# Revised Plan For bathroom to allow for 6'-8" headroom clearance at fixtures.

34 Sterling St Peaks Island, ME 04108  
owner: Mac Medlen CBL = 087 E018001

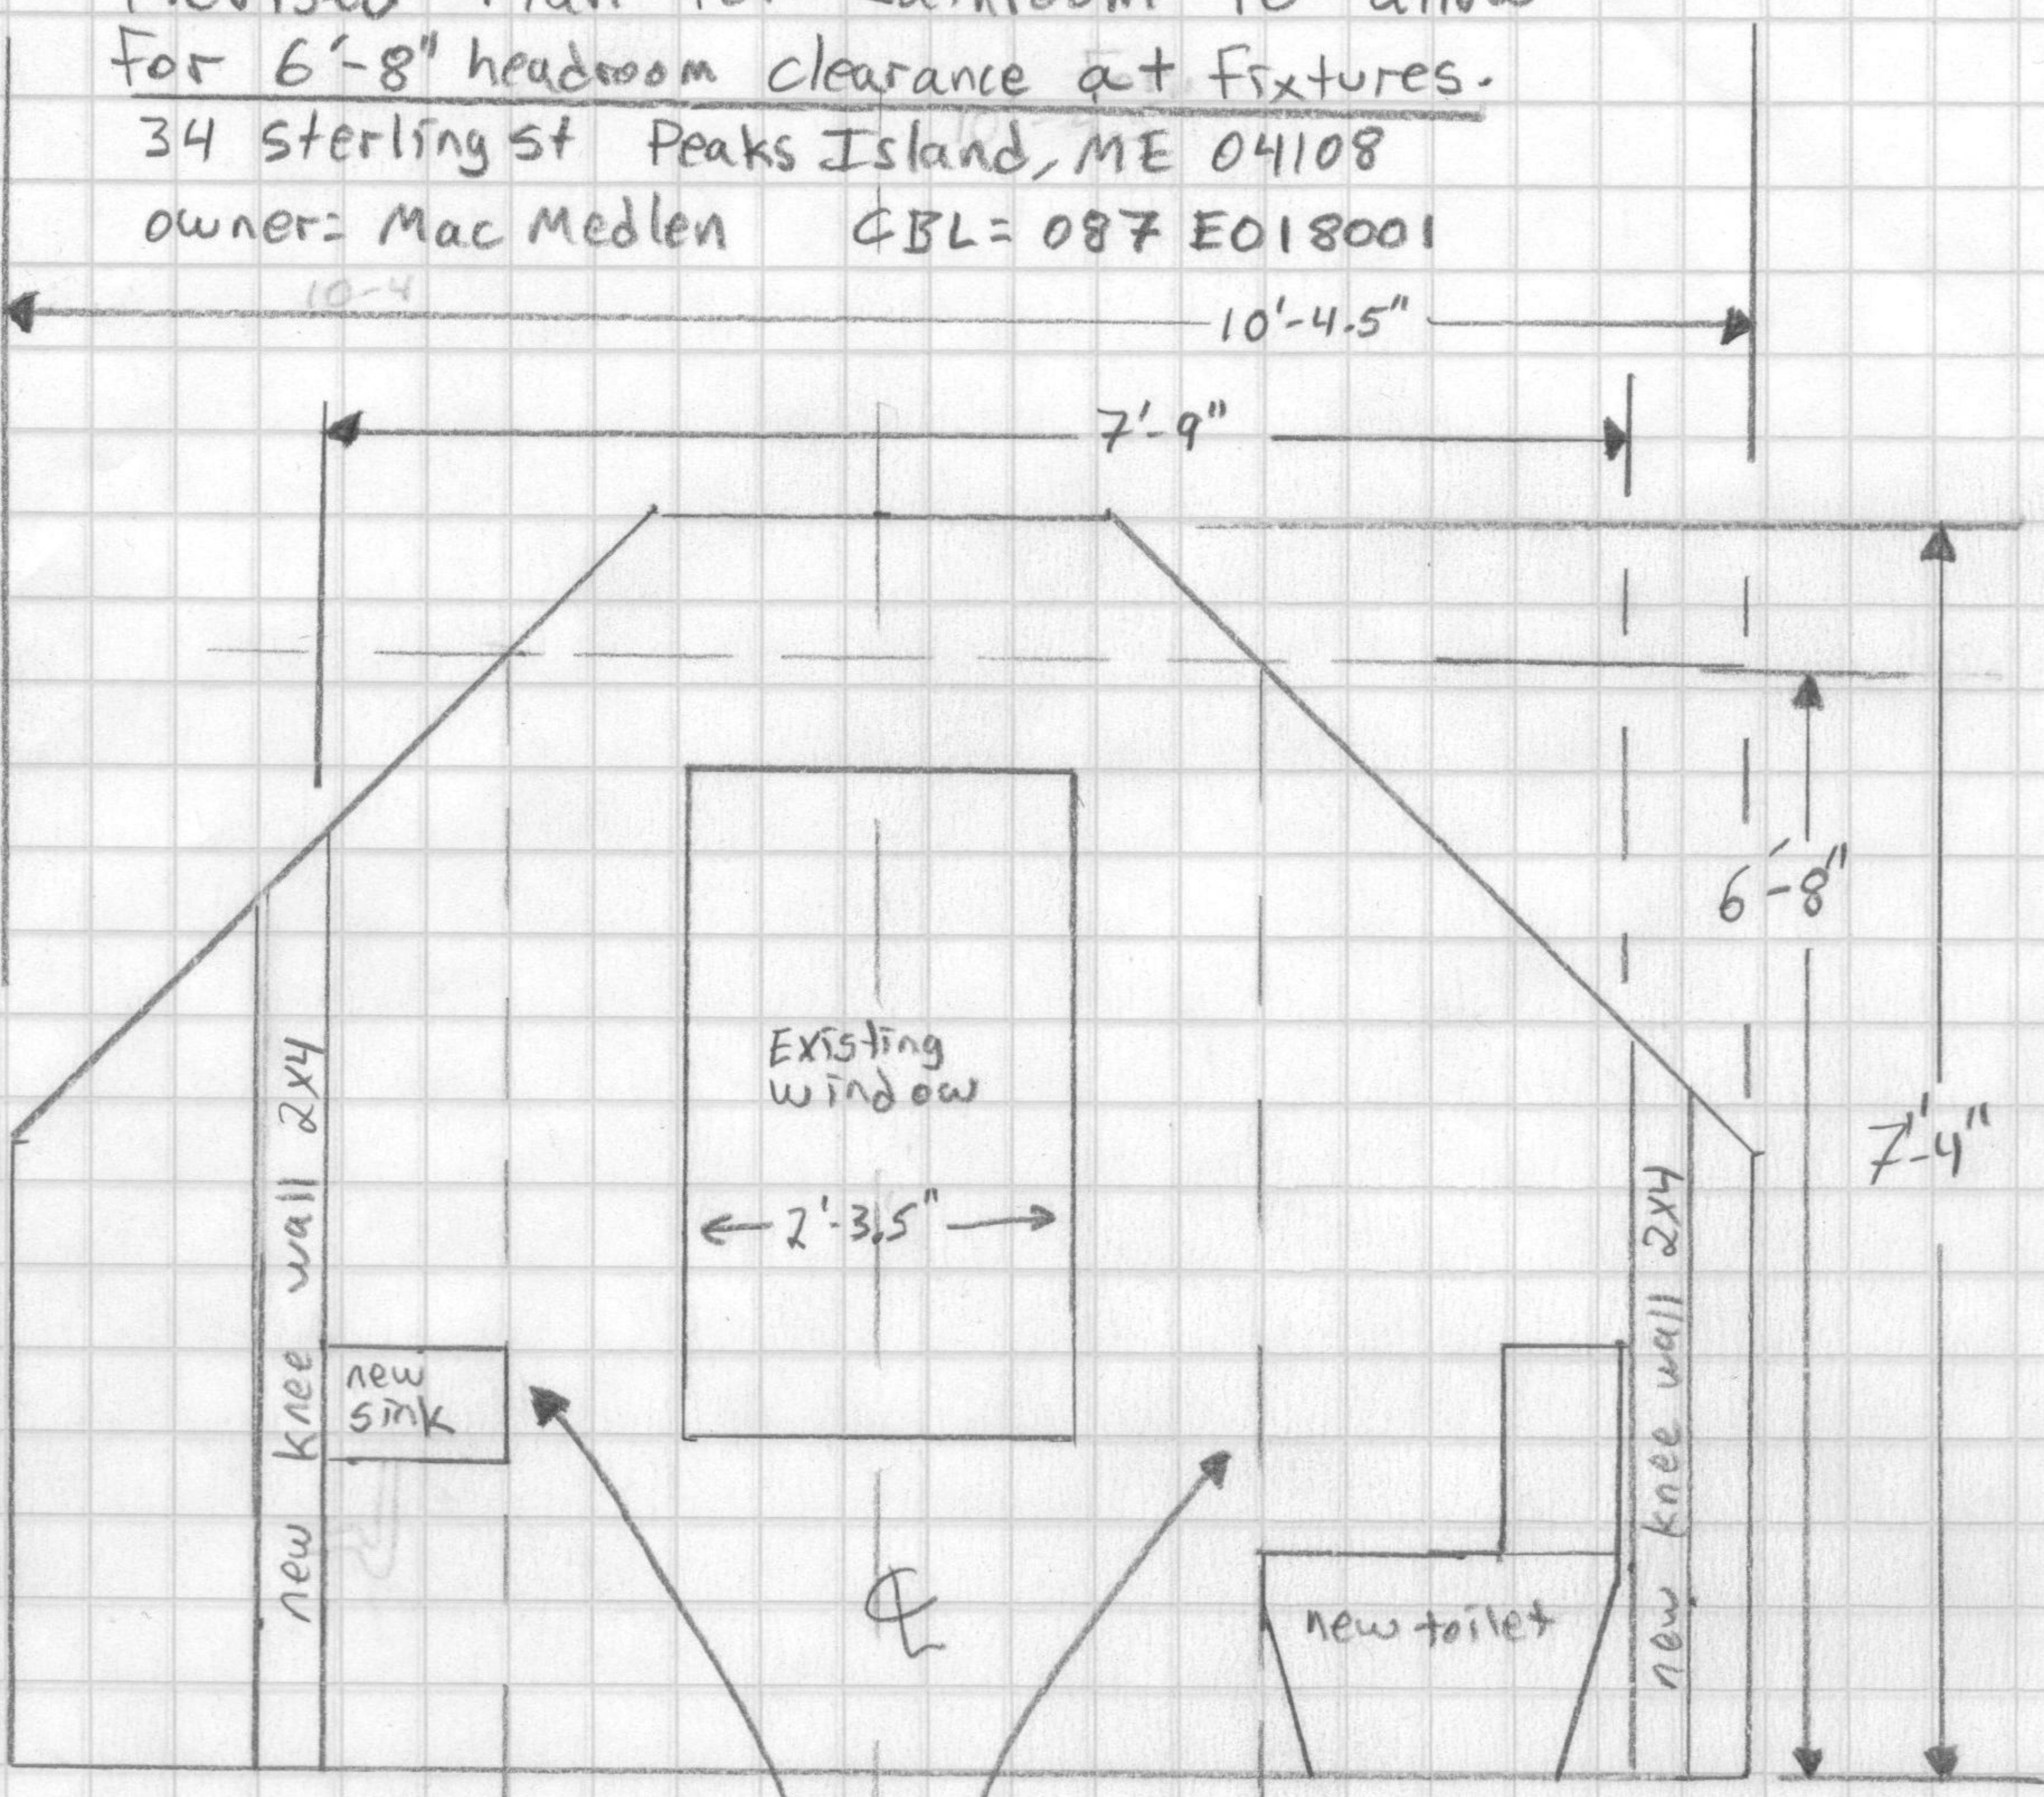
6'-8" Headroom as per  
2009 Intl. Res. code  
Pg. 54 section R305.1  
Exceptions: part 2
